ARCHITECTURE

Project:	FLORENCE COUNTY VOTER REGISTRATION & ELECTIONS COMMISSION BUILDING
Addendum No.:	TWO
Date:	June 8, 2010

REVISION TO WALL SECTION 1/A4.3
 (Reference Drawing: A4.3)

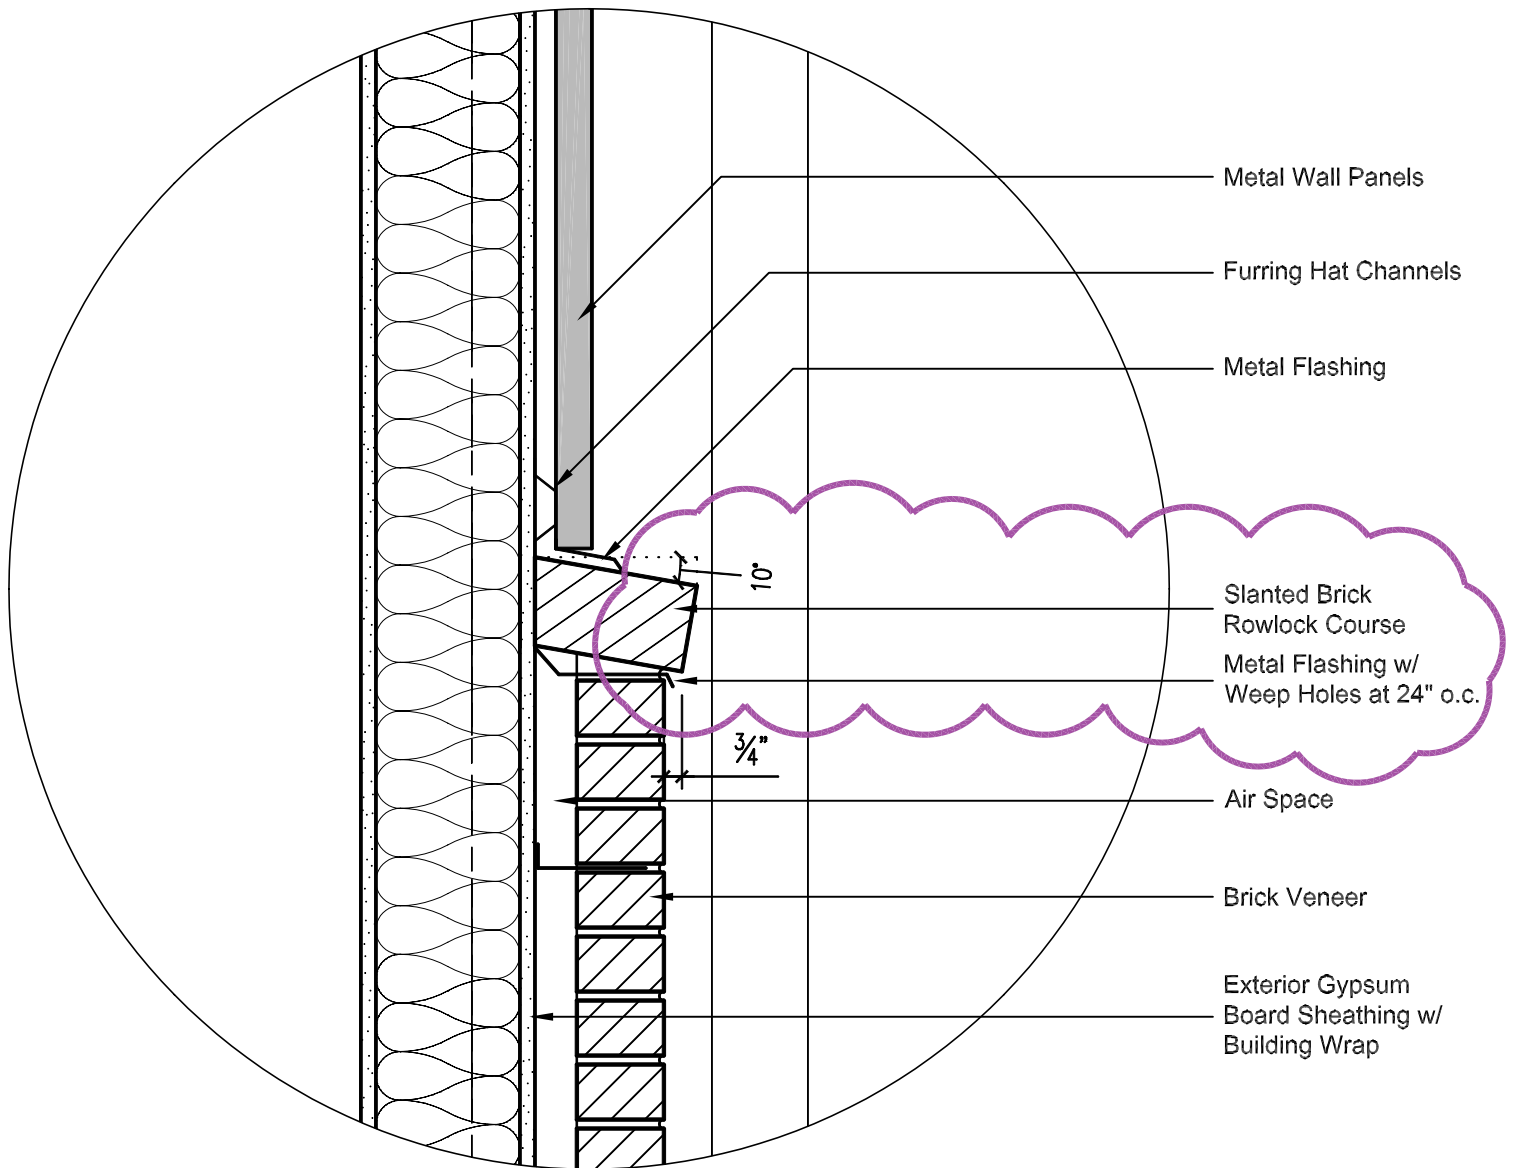
7. Refer to drawing sheet A4.3 and to Wall Section 1.
 - a. See attached Supplemental Drawing SD-05 dated 06.07.10.

Supplemental Drawing | SD-05

REVISED WALL DETAIL A/4.3

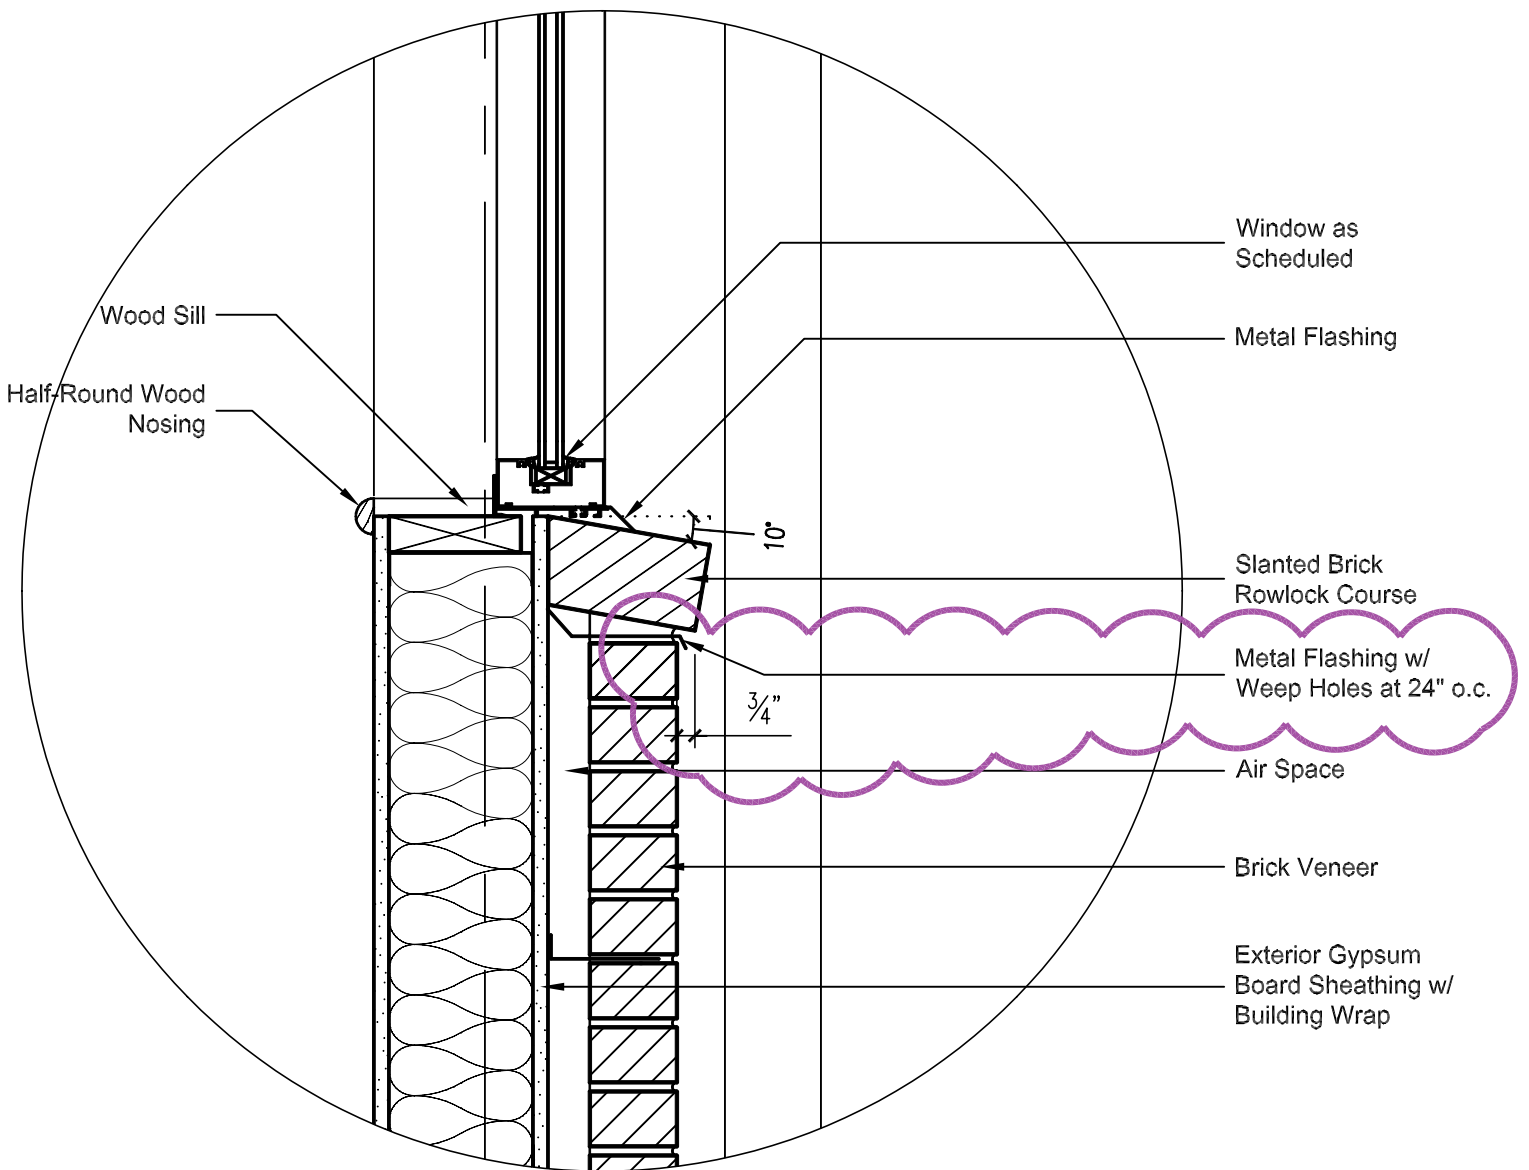
8. Refer to drawing sheet A4.3 and to Wall Detail A.
 - a. See attached Supplemental Drawing SD-06 dated 06.07.10.

Supplemental Drawing | SD-06

REVISED WALL DETAIL C/A4.3

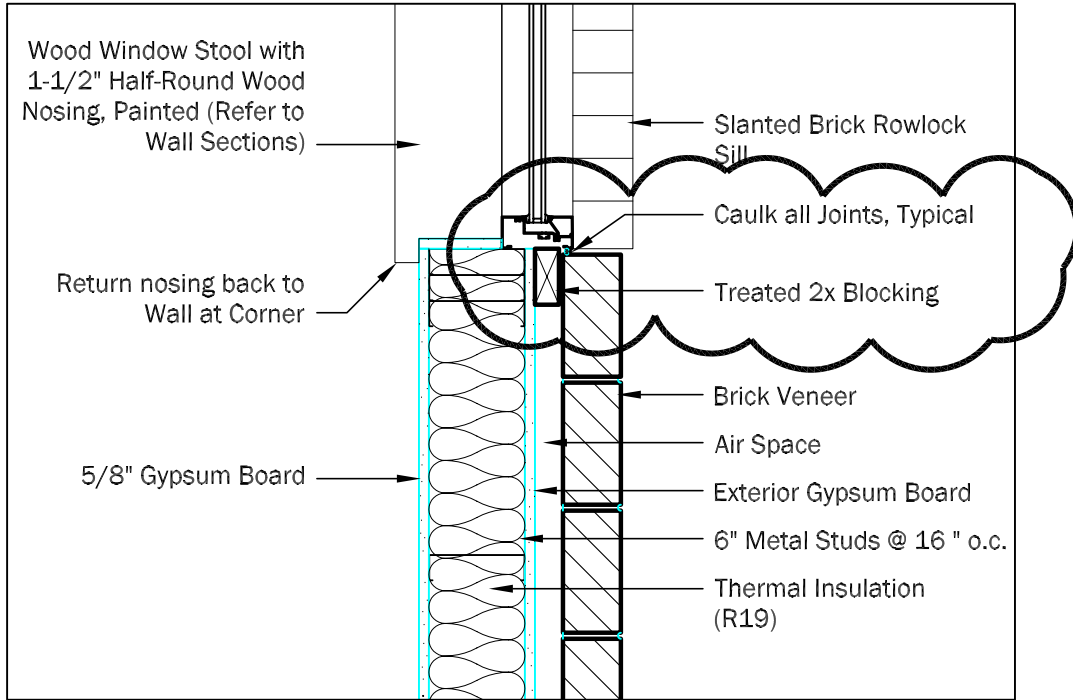
9. Refer to drawing sheet A4.3 and to Wall Detail C.
 - a. See attached Supplemental Drawing SD-07 dated 06.07.10.

Supplemental Drawing | SD-07

REVISION TO PLAN DETAIL F/A8.0-1

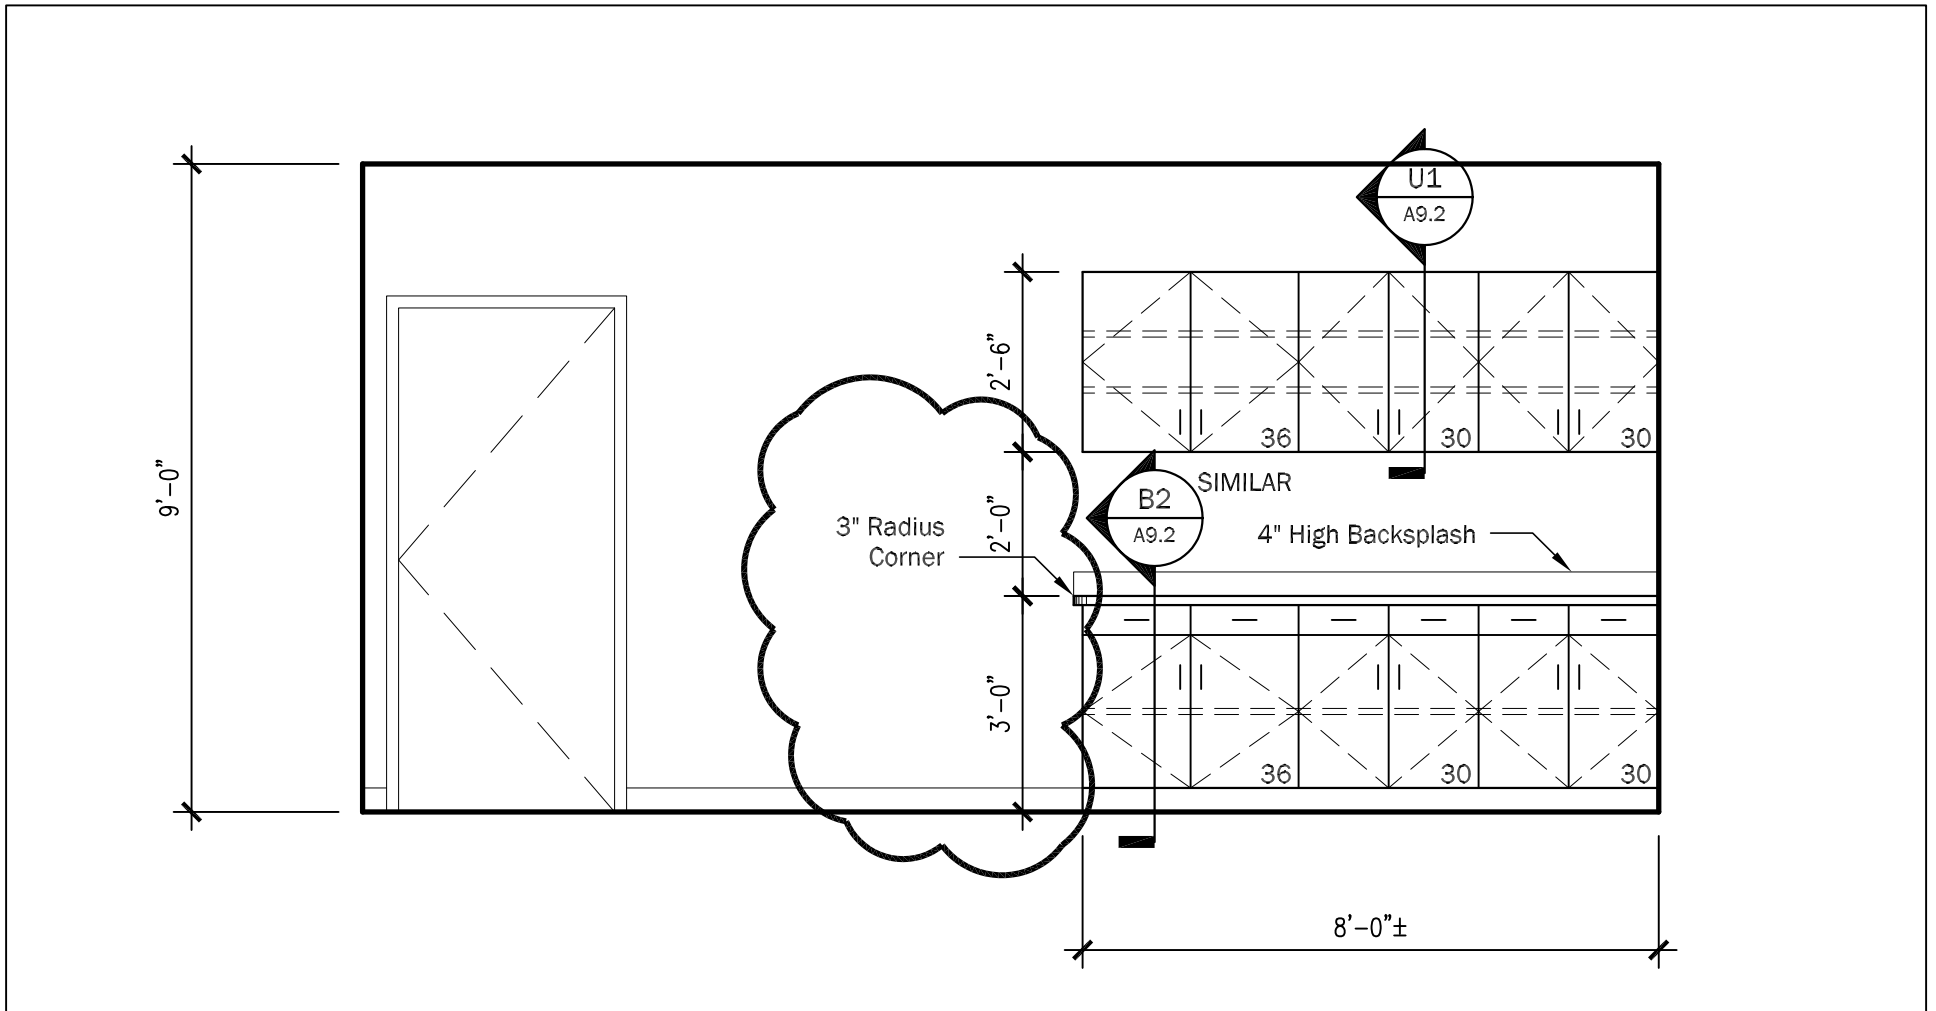
10. Refer to drawing sheet A8.0-1 and to Plan Detail F
 - a. See attached Supplemental Drawing SD-08 dated 06.07.10.

Supplemental Drawing | SD-08

Supplemental Drawing | SD-09

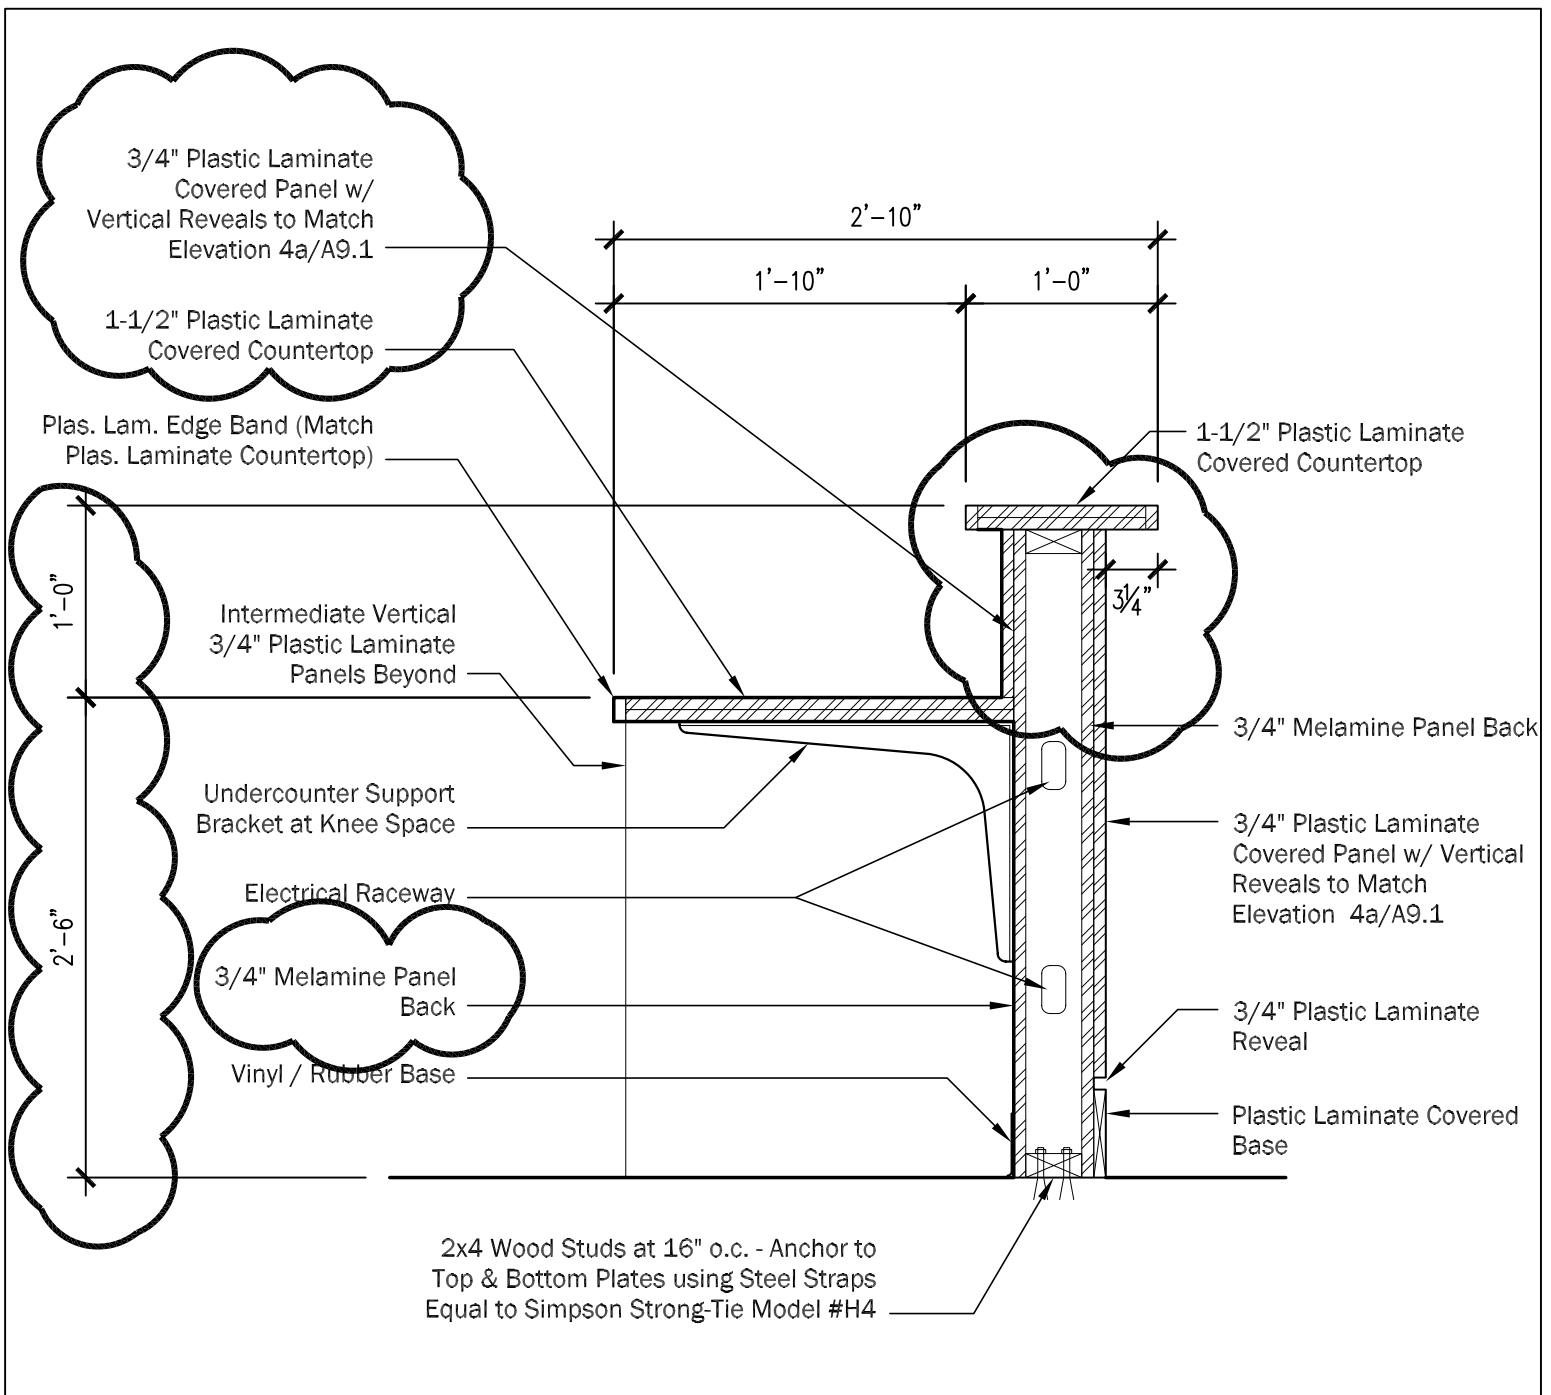
11. Refer to drawing sheet A9.1 and to millwork elevation 5 (Millwork at Supply/Copier/Files 1018)
 - a. See attached Supplemental Drawing SD-09 dated 06.07.10.

Supplemental Drawing | SD-10

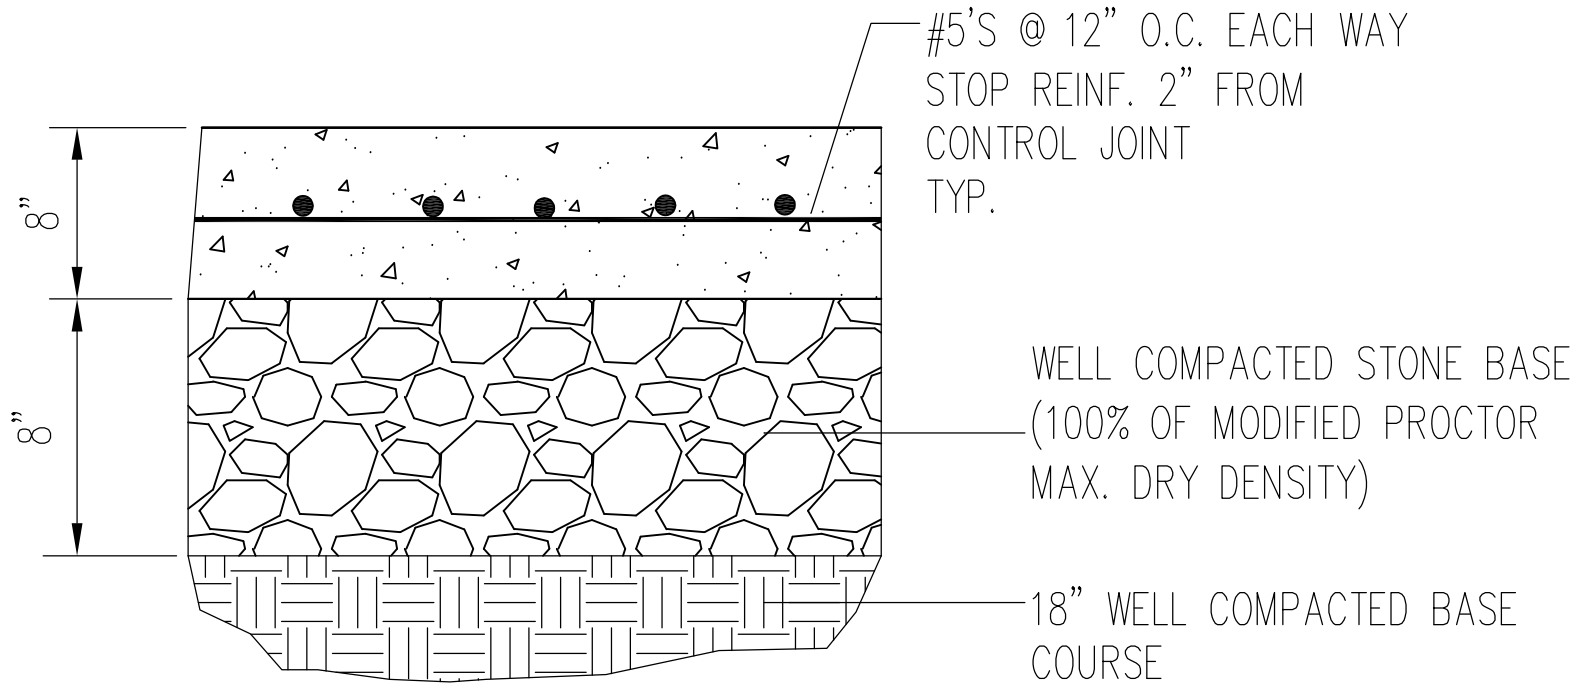
12. Refer to drawing sheet A9.2 and to millwork detail B3, Conference Room Base.
 - a. See attached Supplemental Drawing SD-10 dated 06.07.10.
